**FAIRFAX COUNTY, VIRGINIA**

**MEMORANDUM**

**SUBJECT:** Staff Analysis of Conceptual Plan Amendment CPA 86-C-121-2: Reston Spectrum L.P.

RESTON SPECTRUM LP  
CONCEPTUAL PLAN AMENDMENT  
REMOVAL OF SCREENING WALLS SHOWN ON THE PREVIOUSLY  
APPROVED TOWN CENTER CONCEPT PLAN

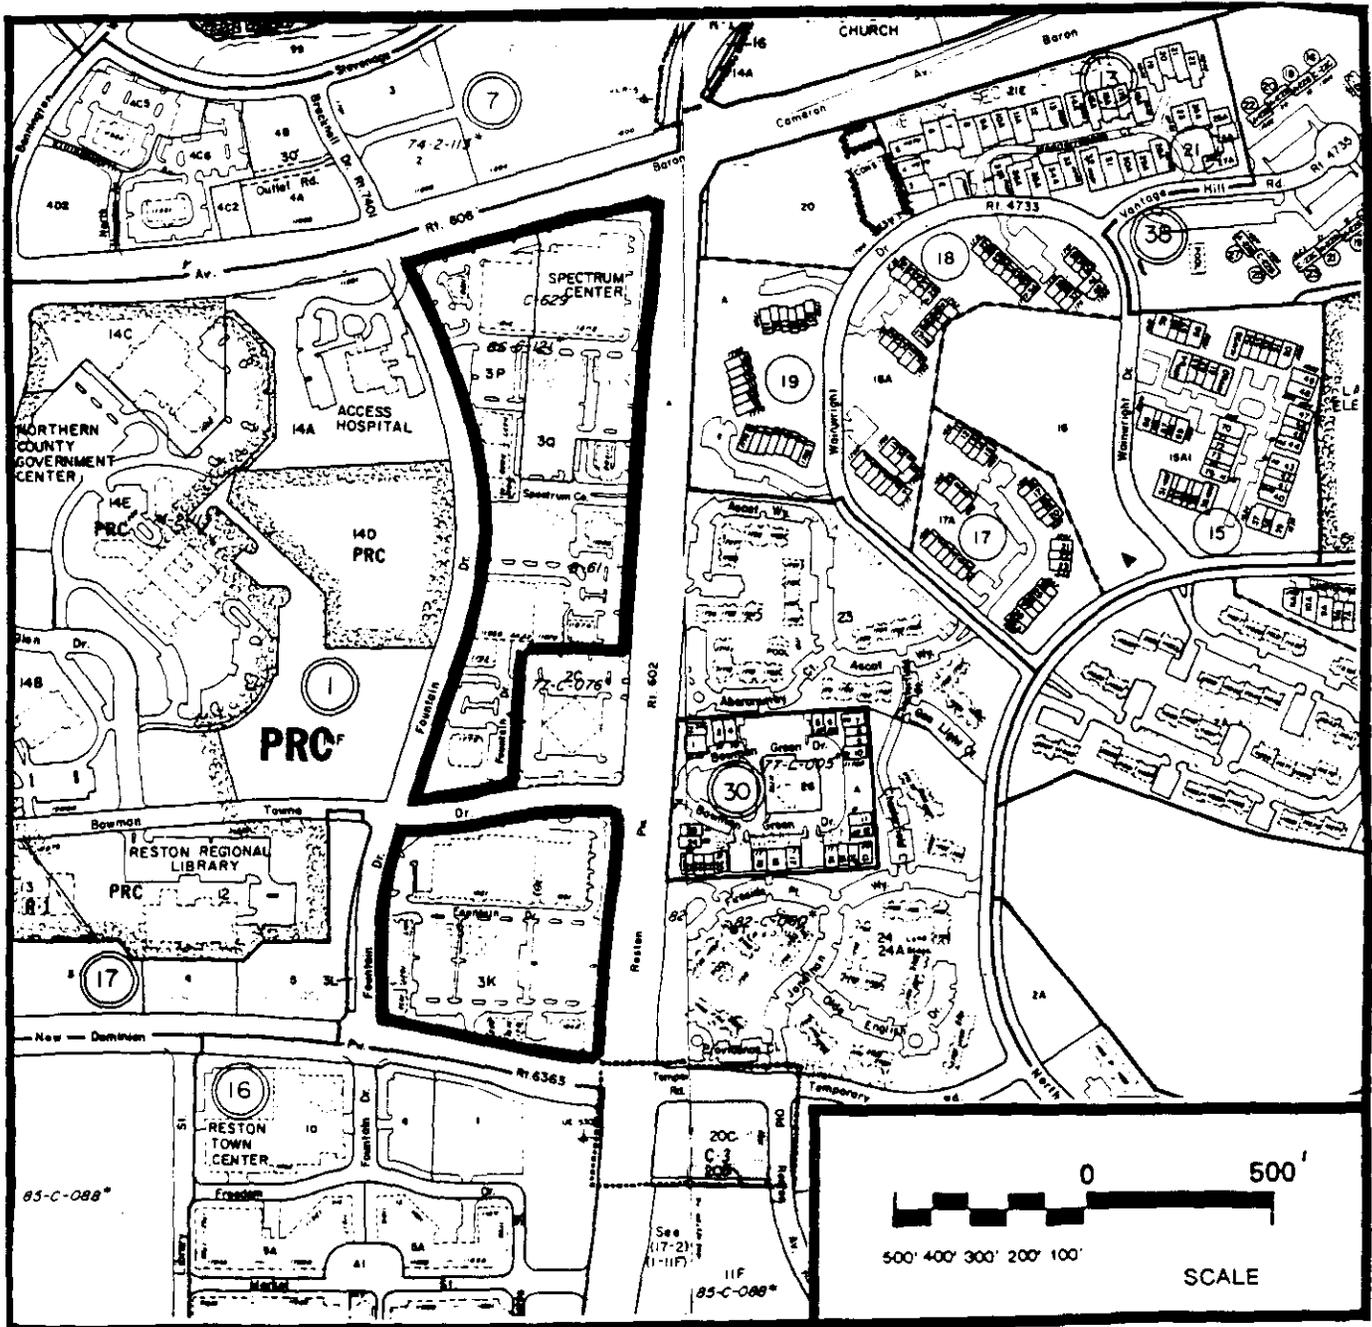
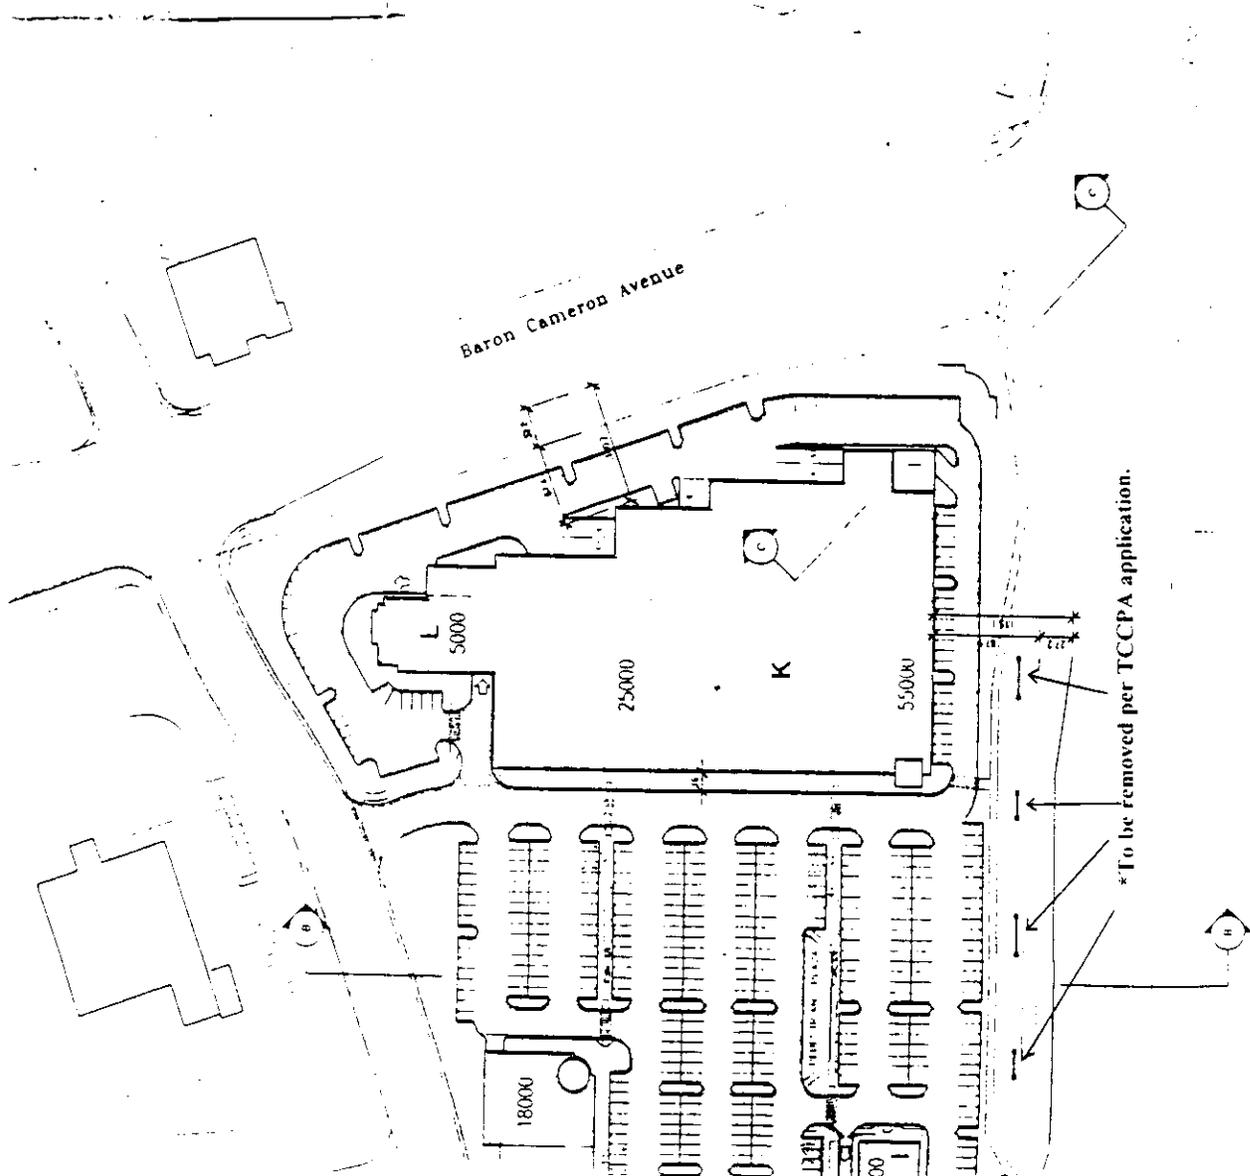
CPA 86-C-121-2 requests approval to delete the architectural screening walls shown along Reston Parkway on the approved Conceptual Plan. The applicant has indicated that, due to the location of utilities and the existing grade differential between Reston Parkway and the shopping center, the installation of architectural screening walls along Reston Parkway is impractical. The applicant is proposing to provide additional landscaping along the Reston

Note 26 of the approved CP requires the applicant to construct a series of landscaped berms and decorative screen walls along its frontage of Reston Parkway in order to reasonably screen the street-level view of surface parking areas from Reston Parkway. The applicant has requested deletion of the requirement for these decorative screen walls. In lieu of the decorative screen wall, the applicant believes that the existing landscaping, which includes combinations of berms and hedges at street level effectively screens the surface parking associated with the retail center, which in some areas is located substantially below the elevation of Reston Parkway. Further, it appears that due to the location of utilities within the planting strip along Reston Parkway, the location of a four foot tall decorative wall would not be permitted.

The area in question includes approximately 2,200 feet of frontage along the west side of Reston Parkway from New Dominion Parkway to Baron Cameron Avenue. Between New Dominion Parkway and Bowman Towne Drive, the grade slopes down from Reston Parkway approximately 20 feet to the parking area of the shopping center. Turf grass is the ground cover over a majority of this slope although portions of the slope are landscaped with various ornamental grasses, creeping euonymus, shrubs and small trees. A few Willow Oaks are located on the slope. The applicant has indicated that additional Willow Oaks have been ordered for planting in the spring to replace those that have died. Along the Reston Parkway frontage from Bowman Towne Drive to Baron Cameron Avenue, a euonymus hedge has been planted adjacent to the trail that runs at grade with Reston Parkway. The parking area is located below the grade of Reston Parkway and the hedge visually serves the same purpose as the proposed decorative screen walls. However, as with the southern portion of the site, the landscaping on the slope between Reston Parkway and the parking areas for the shopping center could be enhanced.

DECORATIVE SCREEN WALLS  
APPROXIMATELY 2' TO 4' IN HEIGHT  
\*To be removed per TCCPA application.

Staff believes that the additional landscaping as shown on the revised Landscape Plan will effectively screen the existing surface parking lot; and therefore supports the applicant's request to delete the decorative screen walls.

Staff recommends approval of CPA 86-C-121-2, subject to the revised Plan Notes dated June 23, 1999.

LANDSCAPE PLAN  
 THE SPECTRUM  
 AT RESTON TOWN CENTER  
 SECTION 97 BLOCKS 2 & 3 AND SECTION 91 BLOCK 1  
 HUNTER HILL DISTRICT  
 FAIRFAX COUNTY, VIRGINIA  
 SCALE 1" = 30' C13 DATE NOV 1994

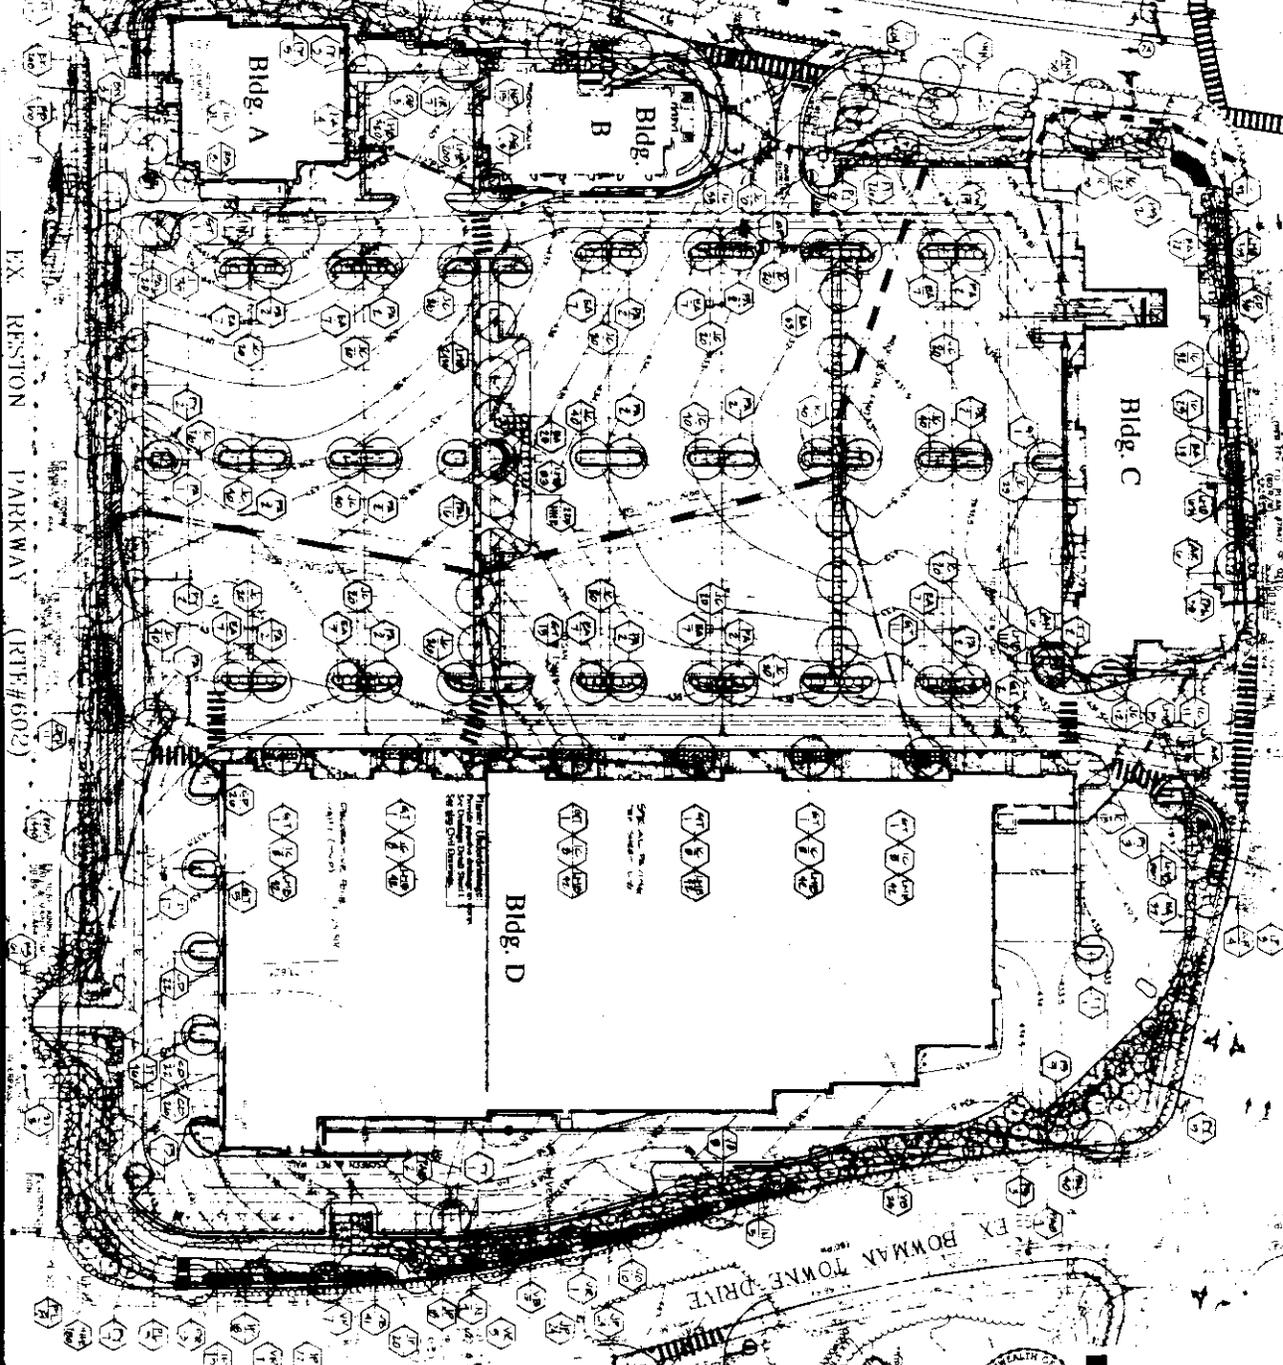
Staff from the Urban Forestry Branch has met on site with the applicant's representatives to discuss additional landscaping which could be provided along the slope. Specifically, staff recommended that additional Willow Oaks be planted to continue the row of trees which currently exists. In addition, staff recommends that additional flowering trees be planted on the slope, which at maturity will serve to screen the parking from Reston Parkway but will not grow tall enough to block the building fronts and signage within the shopping center. Additional ground covers such as Vinca, Liriope, and flowering bulbs could be planted in the mulch bed on the slope to provide a more favorable ground cover for the trees as opposed to the turf grass that currently exists.

The applicant has indicated that additional ground cover and trees have already been ordered to replace vegetation that has died. The applicant has also indicated that additional flowering trees, as recommended by the Urban Forester, will be planted along portions of the slope. A revised Landscape Plan has been submitted, which shows the existing landscaping and the additional landscaping proposed as noted above. A reduction of this revised Landscape Plan is set forth in Attachment 9. The Conceptual Plan Notes have been revised to commit to providing landscaping as indicated on the revised Landscape Plan and to delete the reference to the decorative screen walls. The previously approved Plan Notes will remain in effect.

The applicant should provide supplemental tall shrubs and ground plantings as natural screening in place of the screening walls.
